## Response to Submissions relating to Modification to MP06-0309 (Mod 5)

### Trinity Point Marina and Mixed Use Development

April 2015

**Figure 1 - Proposed and Revised Modification to building positioning and orientation.**

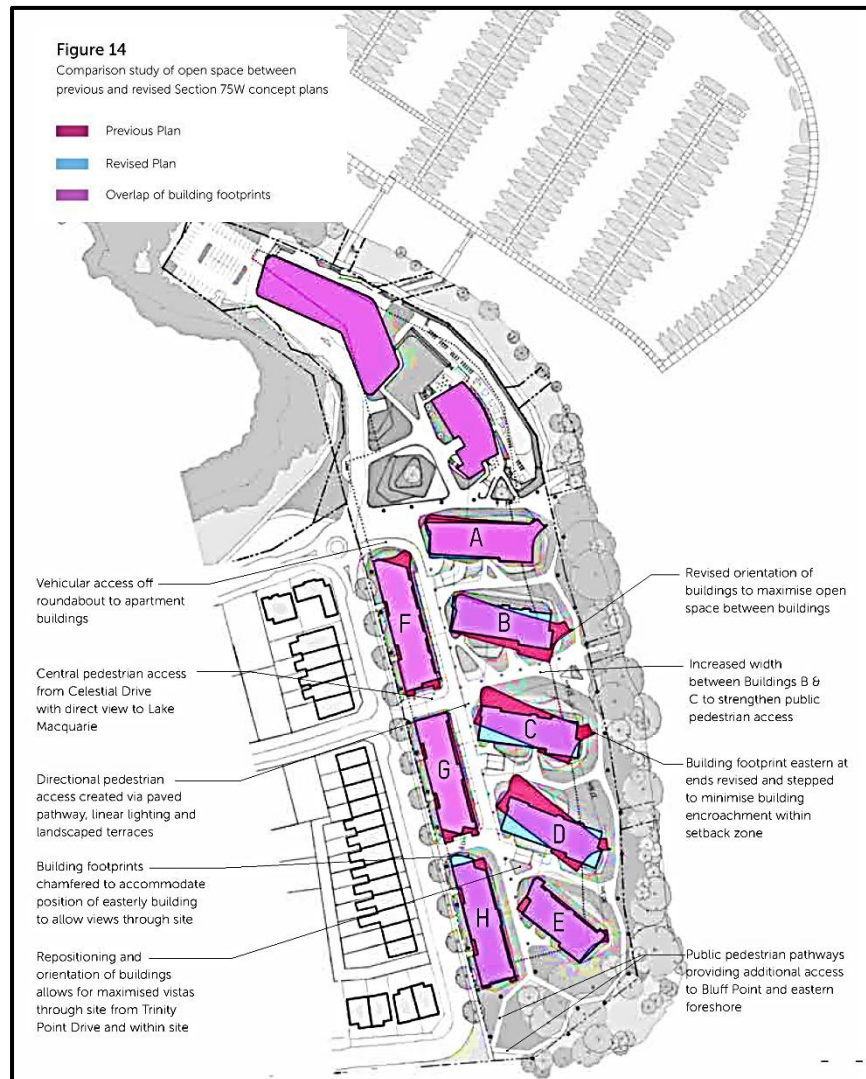
Numerous revisions are proposed within this RTS to the positioning and orientation of accommodation buildings in the central and southern precincts within the site. These revisions arise from the additional analysis undertaken in response to local SEPP 65 Panel comments and from the design review process undertaken with the local SEPP 65 Panel.

The review process identified the need to reinforce and strengthen primary and secondary vistas/views and pedestrian links and permeability, from the adjoining public road system, through the central and southern precinct, towards the lakeside pathway and the foreshore edge. These revisions to the modification are described overpage and are graphically presented in Figure 14 of the Design, Justification & Comparison Document (**Appendix B**), with Figure 14 reproduced overpage as **Figure 1**.

This revision includes:

- Reinforcement of primary vista and pedestrian connection from Trinity Point Drive at primary site entry (roundabout), by widening the space between the forecourt/restaurant/function building and the two accommodation buildings to the south of the connection including:
  - Shift in orientation and minor reduction in building mass of building A to widen the proposed vista from Trinity Point Drive; and
  - Reduction in building mass by shortening and angling the edge of building F to provide an improved angle towards internal vistas.
- Reinforcement of primary vista and pedestrian connection from Trinity Point Drive/Celestial Drive by widening and straightening the space between built form including:

- between accommodation buildings F and G, by minor shortening of building F (to provide 15m building separation); and
  - between accommodation buildings B and C (to provide 30m+ building separation widening towards foreshore), by shift in orientation and mass of buildings B and C.

- Reinforcement of other vista and pedestrian connections leading from Trinity Point Drive including:
    - Angling edge of building F and shift in orientation of building B (to provide angled 12m widening to 19.5m then 26m building separation between accommodation buildings A and B); and

- Angling edges of buildings G and H and shift in orientation of building D (to provide angled 8m, widening to 15m, then 30m building separation).
  - Reinforcement of visual and pedestrian experience along eastern perimeter shared pathway by reducing extent of eastern building footprint of buildings B, C, D and E. Some built form is maintained within the approved 20m setback, offset by the provision of additional space behind the 20m setback to form part of vistas, pedestrian links and public and semi-public space. The eastern extent of Building A has been varied but retains a north facing picture window that frames prominent views across the marina and the bay. Building A addresses the active waterfront east of the tourism and hospitality precinct and the strong architectural expression is considered appropriate as it flags the accommodation precinct and provides a visual punctuation mark between the two precincts. Design development will ensure an appropriate amenity is provided to the perimeter shared pathway which extends southwards from the node created by the intersection immediately to the north of the primary east/west pedestrian link and the north-south shared pathway system, which once past Building A return back into the development site; and

- Inclusion of additional access way connections by joining the two internal access ways (to provide a combined single north-south access way) and including an entry (only) connection from the north at the proposed roundabout on Trinity Point Drive. This reduces the need to accommodate internal larger occasional vehicle turning movements and to maximise landscaping, pedestrian and parking opportunities as part of the accessway and ground plane. The connections provide flexibility to consider one way or two way arrangements as part of further design development as part of development applications. Additionally, the concept includes a refined basement extent that removes a second level basement in the southern precinct from that shown in the modification application whilst maintaining (and in some locations increasing) deep soil and landscaping zones at the ground plane. Concept basement footprint has been updated within the documentation to reflect current design development.

Figure 3 – Comparison on building separations and vistas between approved and revised modified concepts (*Appendix B* includes larger versions of these figures).

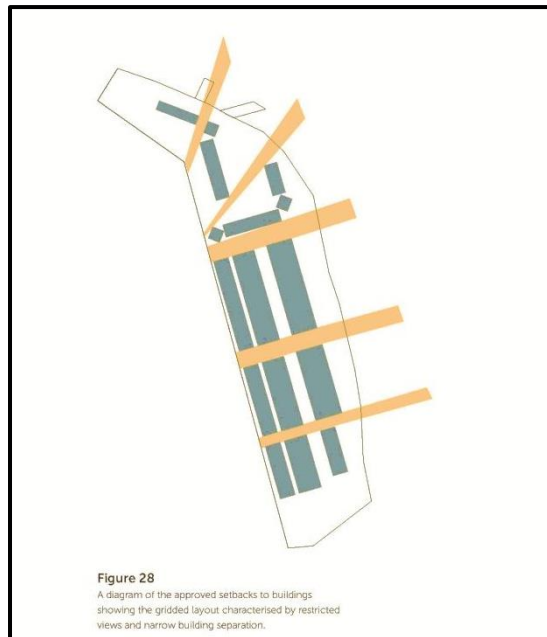
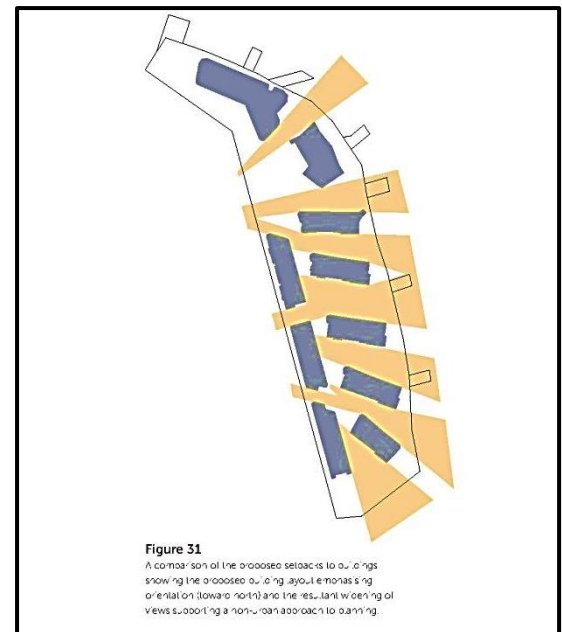
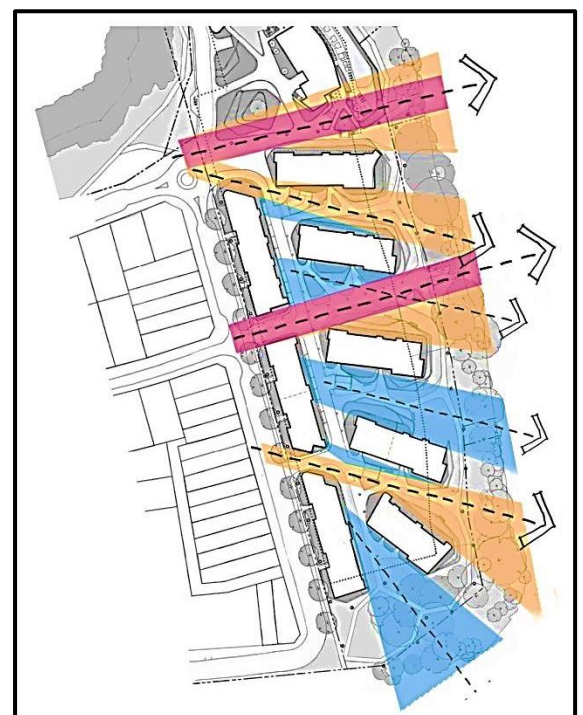
Overpage as **Figure 3** are extracts of figures that illustrate comparison between the approved concept plan (left hand side) and revised modified concept plan (as updated with this submission) (right hand side) on building separation and vistas.

Figure 9 – Site Plan.

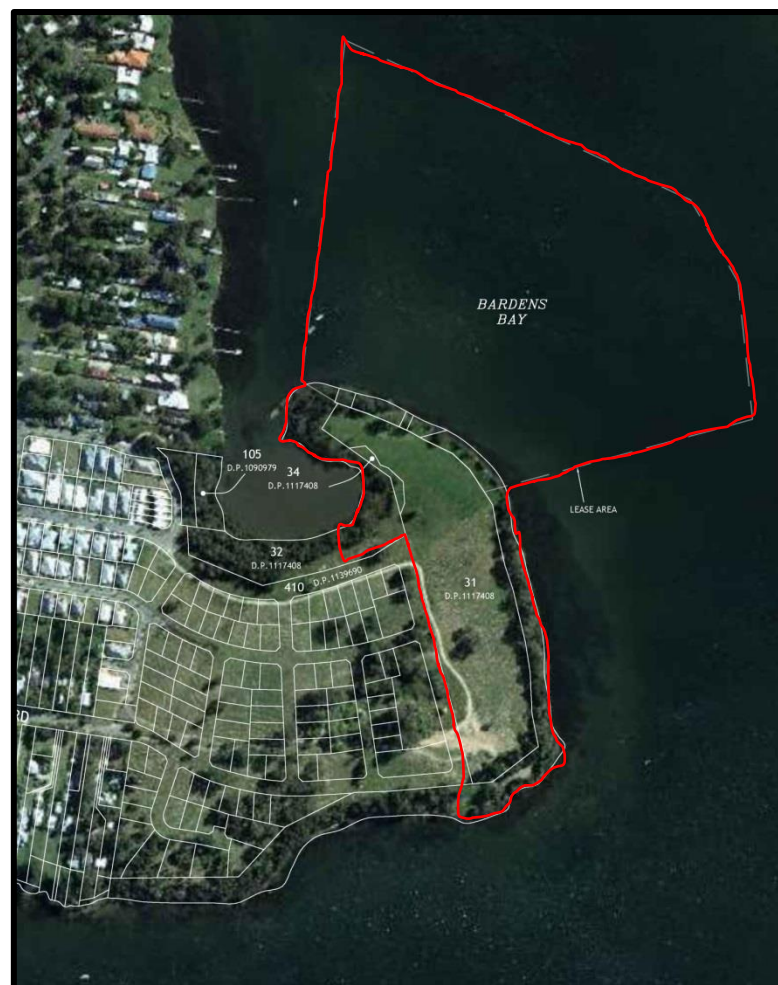
DPE requested clarification regarding any modifications to the site boundary for the concept approval.

The revised modified concept applies largely to the same site as the approved concept, other than:

- For thoroughness, the public reserve bordering the site has been included within the site (part Lot 32 and Lot 34 DP 1117408) rather than limiting it to just the parts of the reserve covered by legal easements (as per approved concept). Note at the time of concept approval, the land was in the process of being acquired as public reserve. Lake Macquarie City Council as now owner of the reserve has provided landowners consent relating to Lots 32 and 34 and the modification application. The inclusion of the reserve within the site area is sought for consistency and clarity, as the revised modified concept envisages future works within that reserve outside

- The area of the approved concept labelled part Lot 33 (currently part Lot 410 DP 1139690) is land which is currently under construction and is to be dedicated as public road as part of Stage 5 of the adjoining residential subdivision (and will provide the concept plan site with its legal public road point of access). That land is not sought to form part of the concept approval site area, noting that works within that part of the public road (once dedicated) will be required as future conditions of consent (ie for construction of identified roundabout and other road modifications at the entry to the concept plan area). Consistent with the concept approval, the 'site' does not otherwise extend to other lands to be dedicated for public road as part of the adjoining residential subdivision as outlined in Section 1.1 of the EA.

Figure 10 - Comparison between approved and modified proposal against updated 2012 Flood Planning Levels.

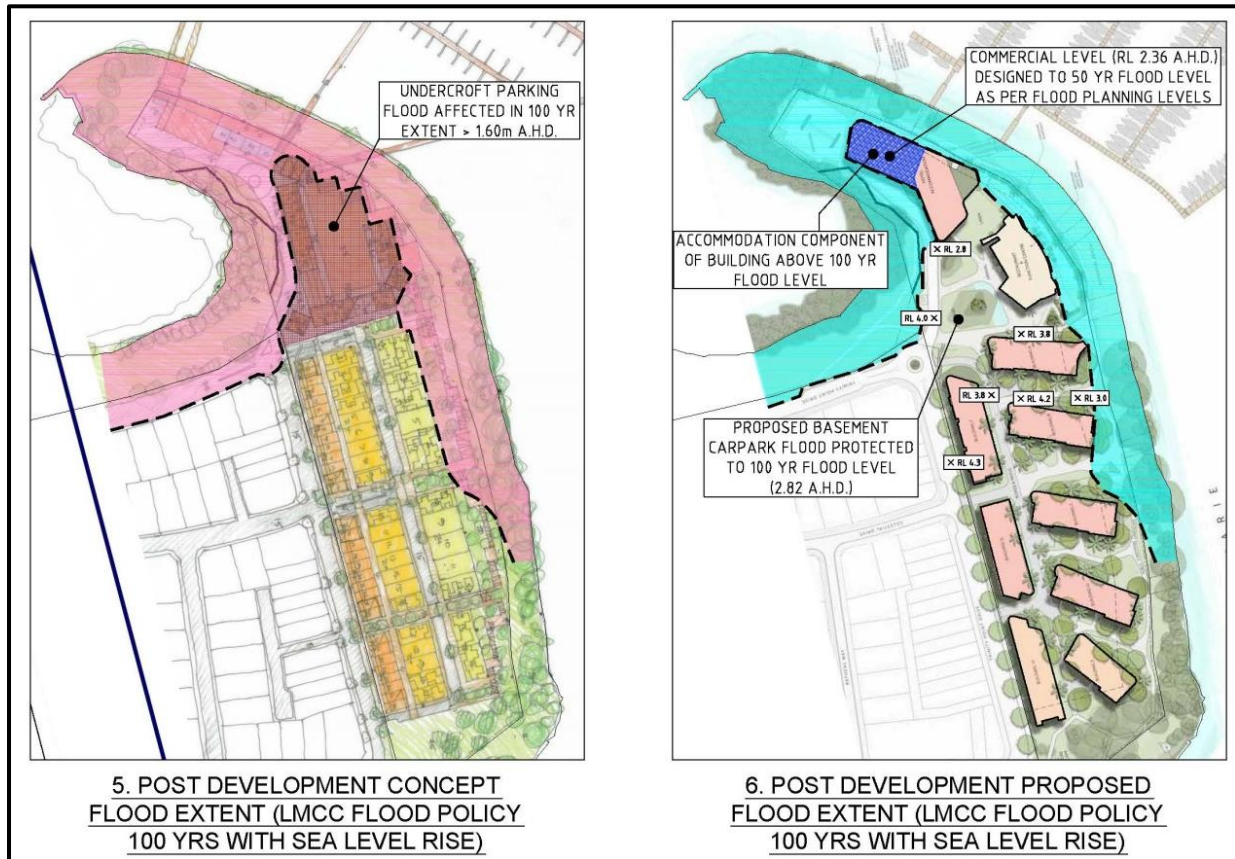
- 1) Flood levels on site as shown in approved concept plan Principle 12;
- 2) Updated flood planning levels on site, consistent with 2012 Flood Study and Council's determined flood planning levels;
- 3) 2012 Flood Planning Levels from (b) overlaid onto approved concept plan;
- 4) 2012 Flood Planning Levels from (b) overlaid onto modified concept plan;
- 5) Post development flood immunity from 2012 levels for approved concept plan; and
- 6) Post development flood immunity from 2012 levels for modified concept plan.

**Figure 10** overpage provides an extract of that plan, parts (5) and (6).

Other than updating the flood planning levels to reflect current policy (and designing the modified concept to suit), the only necessary additional measure for the modified concept as identified in the 2014 report is the inclusion of a flood gate in one location at a pedestrian connection area in the modified concept as part of barrier protection. A further update to Principle 12 has been proposed to identify this additional measure.
